**EAST GOSHEN TOWNSHIP
PLANNING COMMISSION
Meeting Agenda
Wednesday, July 1, 2020
VIA Telephone / Video Conference
7:00 PM**

Date: 6/25/2020
To: Planning Commission
From: Mark Gordon, Township Zoning Officer *mlg*
Re: Synthes USA / JABIL / Land Development Application

**RE: Jabil Finishing Plant Expansion, 1303 Goshen Parkway
Preliminary/Final Land Development Plan – 2nd Submission**

RE: 1303 Goshen Parkway – Preliminary / Final Land Development
Jabil Finishing Plant Expansion
1303 Goshen Parkway, West Chester, PA 19380
Mainstay Project Number: 19360
Pennoni / EGT Reference: EGOST00131

C6.03

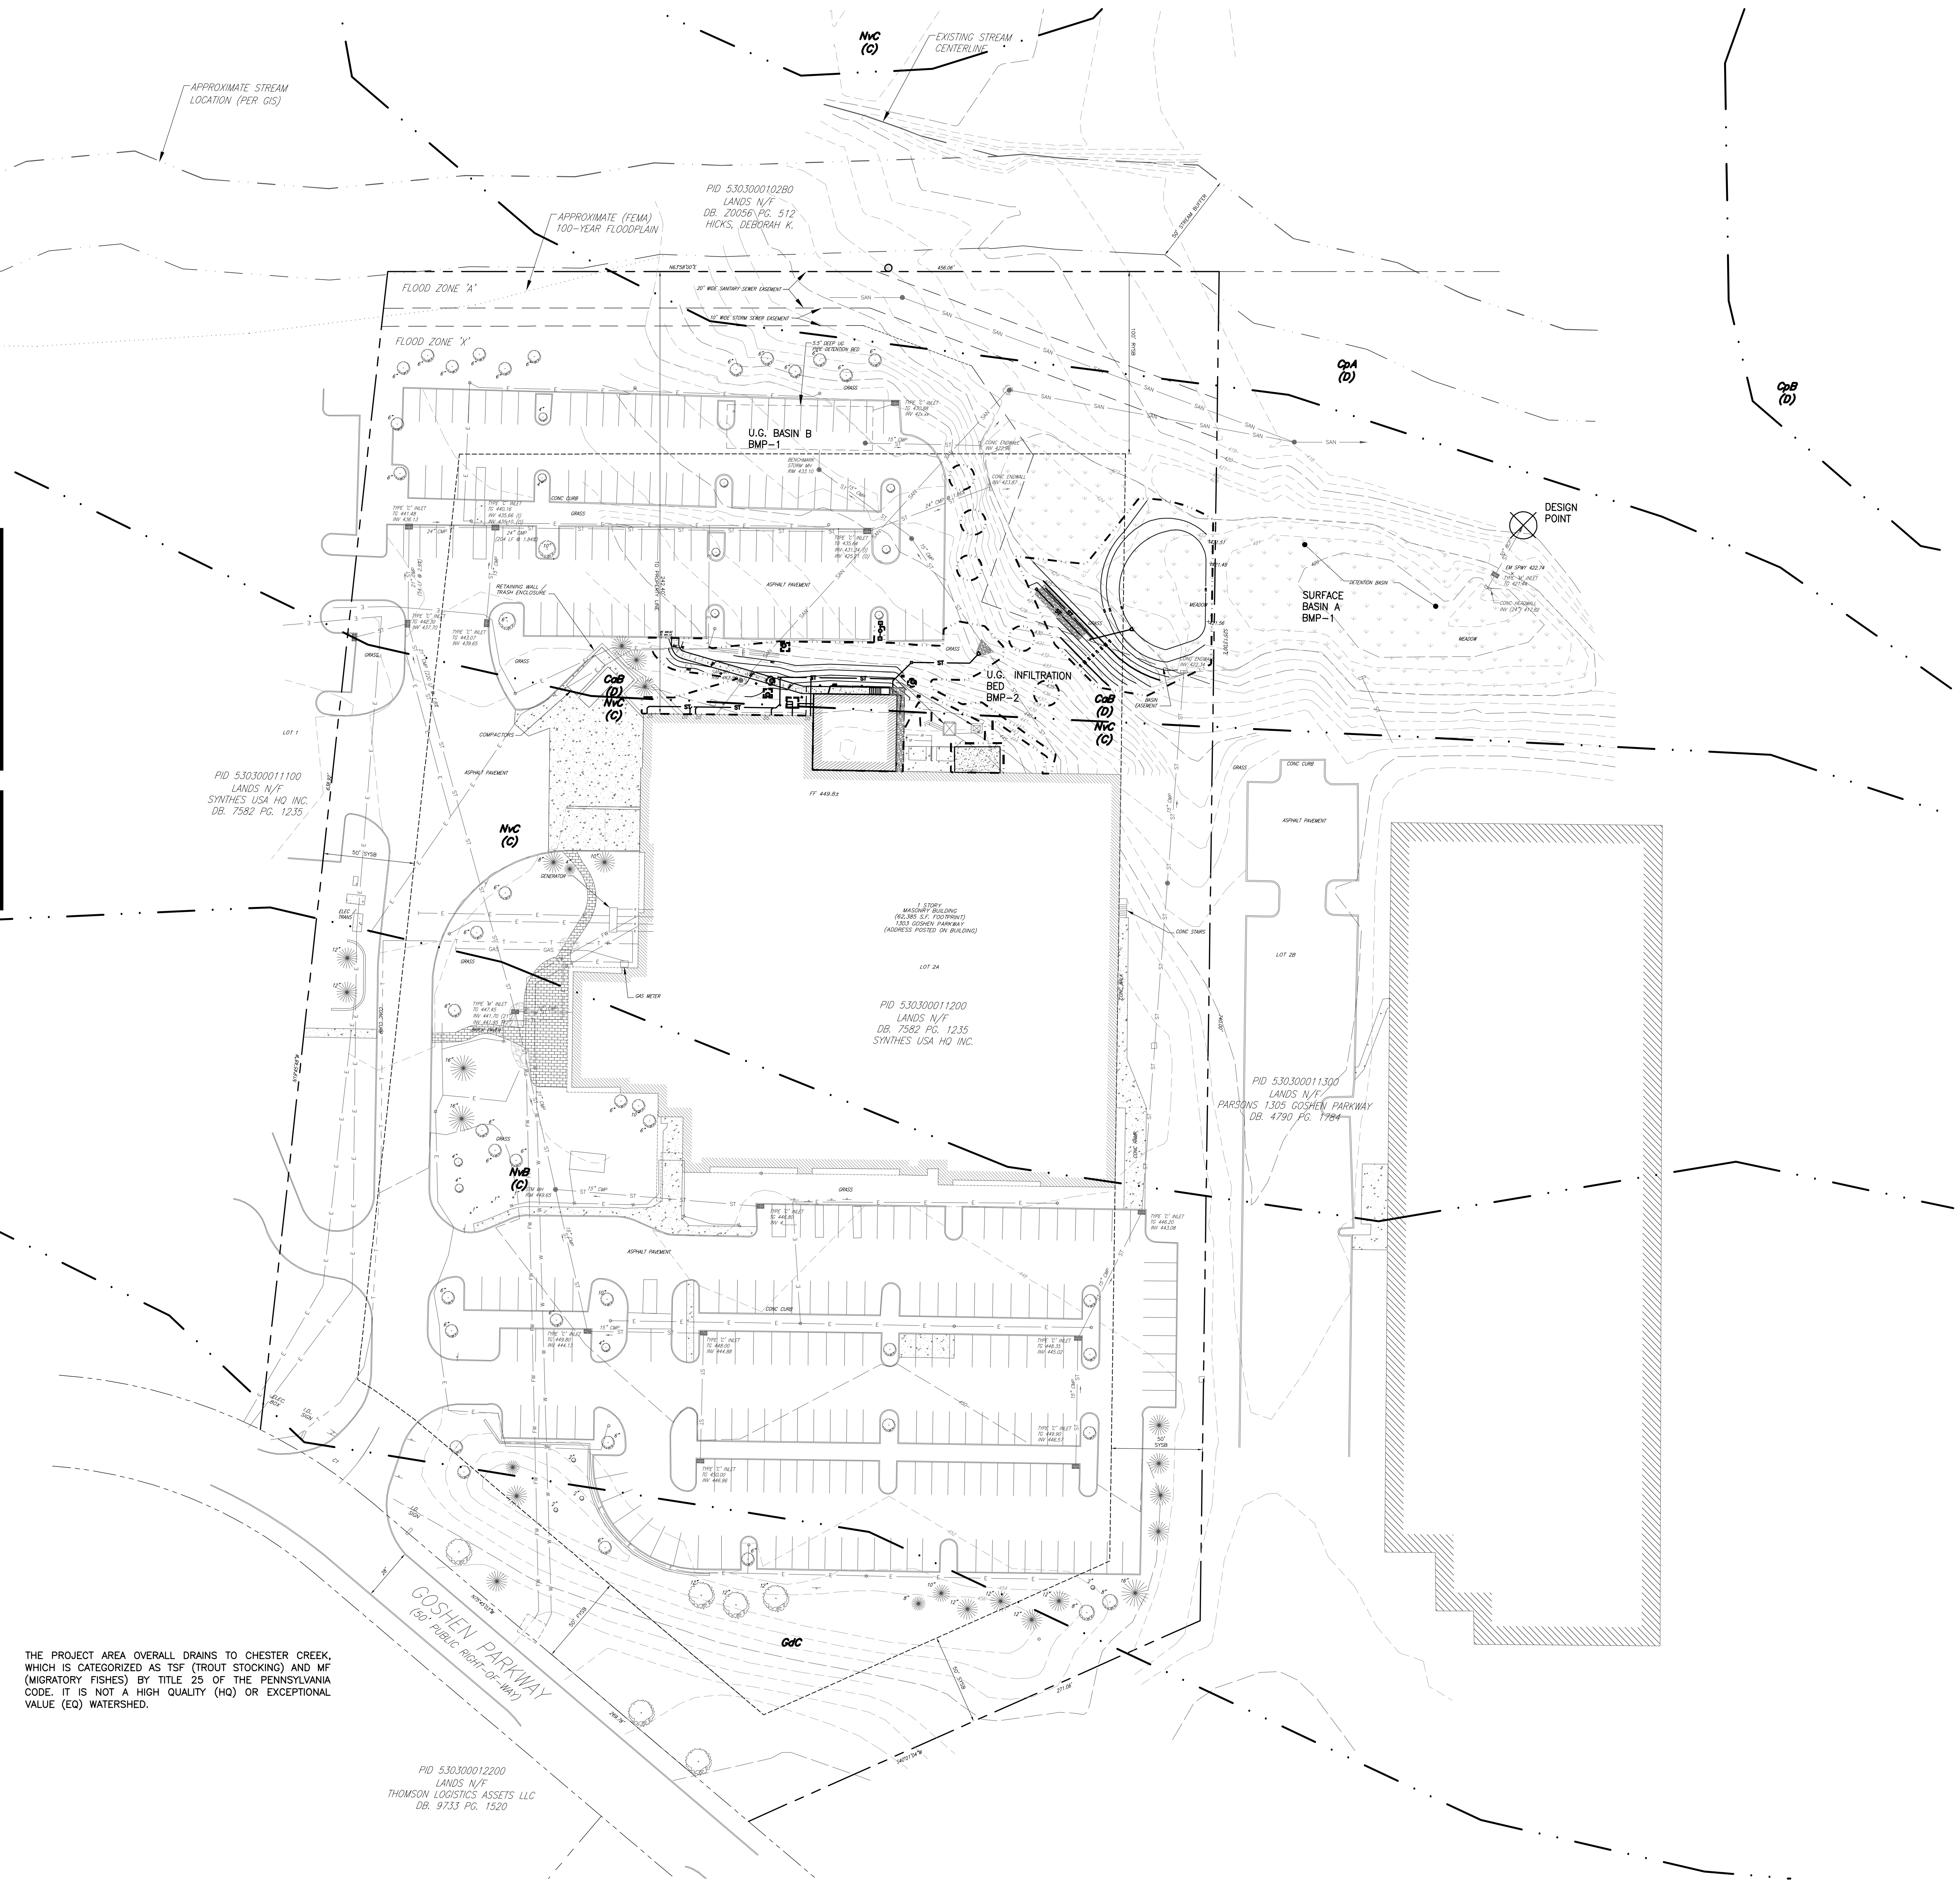
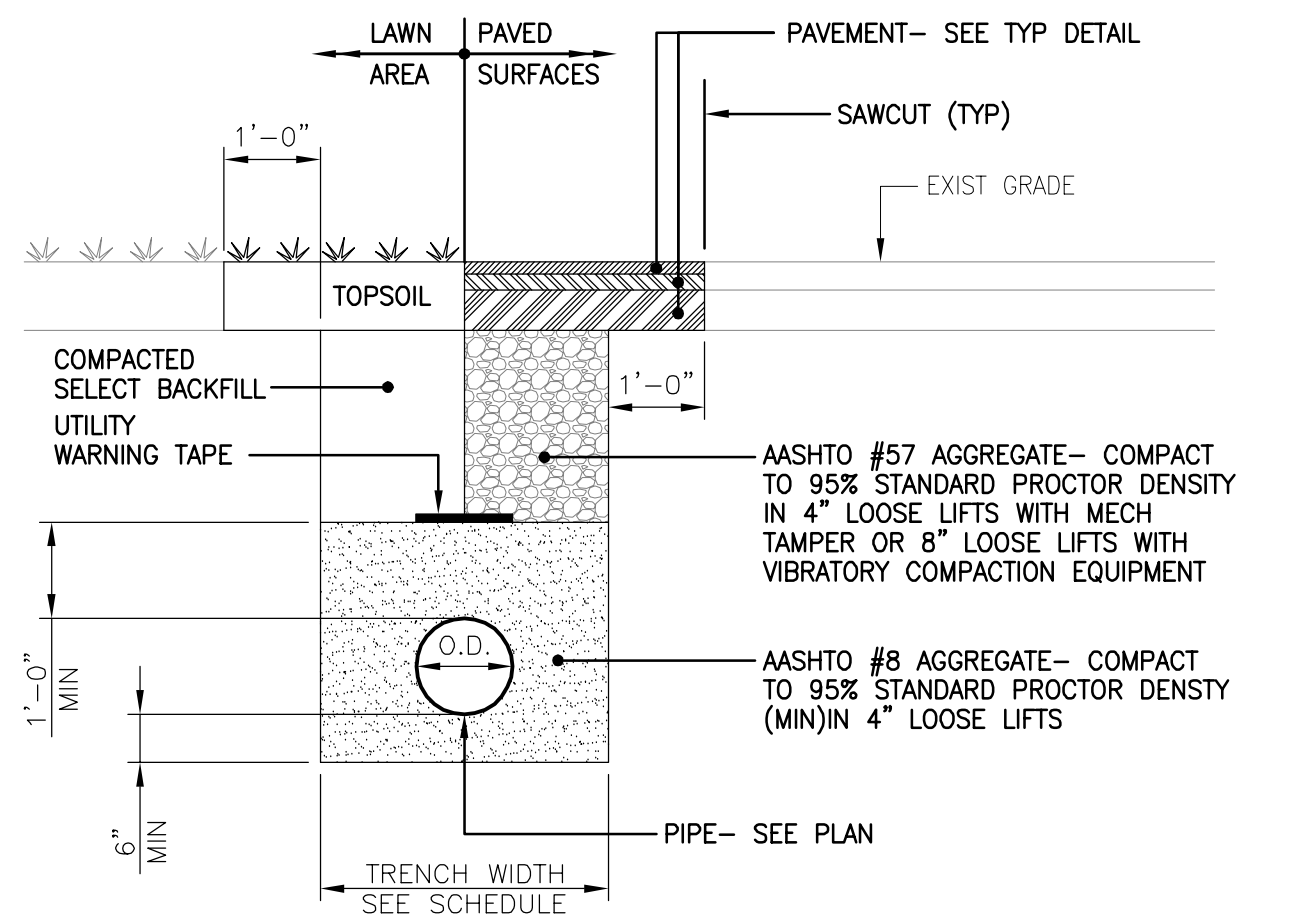
19. Please provide a statement, signed by the applicant, acknowledging that any revision to the approved SWM site plan shall be submitted to and approved by the municipality and that a revised erosion and sediment control plan shall be submitted to, and approved by East Goshen Township for a determination of adequacy prior to construction of the revised features on the PCSM Plan. (§195-27.A(3))

20. Please provide the required signature block signed and sealed by the qualified licensed professional responsible for the preparation of the SWM site plan. (§195-27.A(4))

Resolved. The applicant has provided the statement on Sheet C6.03.

Resolved. The applicant provided the signature block on Sheet C6.03.

The following statement with signature line has been added to the Stormwater Management Plan (Sheet C6.03):
